SER13-015 Rev A
07/15/2014

SUBJECT: Direct Drive Suction Line Fitting

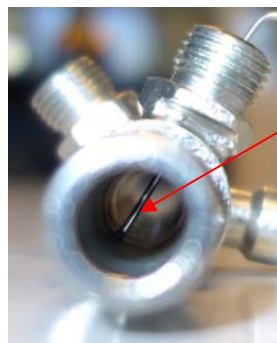
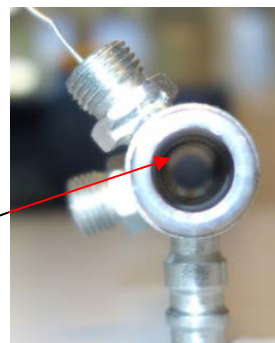
Example of
"unobstructed"
port.

Example of
"obstructed"
port.

If an obstructed port is found, the blockage can be removed by drilling out the braze material with a .125" or 3.17mm drill bit. If the fitting is installed in a system it is necessary to remove the fitting from the refrigeration system and drill out the material at a workbench. This is to prevent drill material from entering the refrigeration system.

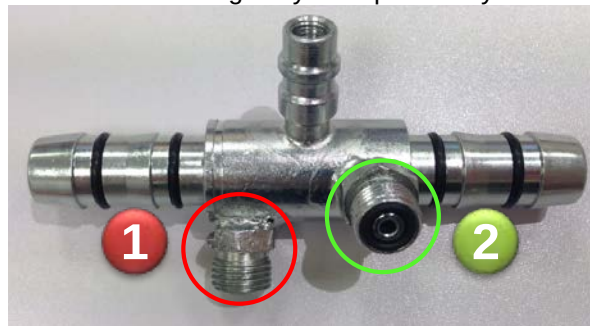
It has come to our attention that the multi-port suction line fitting that was recently introduced on the direct drive product line, may be delivered with one or both of the oil return fittings blocked with brazing alloy. The potentially affected ports are shown as #1 and/or #2 below.

It is highly recommended that prior to installation this fitting be visually checked for no obstructions that could impact compressor reliability. This inspection is to ensure lubricating oil can return from the oil separator to the compressor crankcase. Further to this, if a unit experiences a road compressor failure it is advisable to check for this condition.
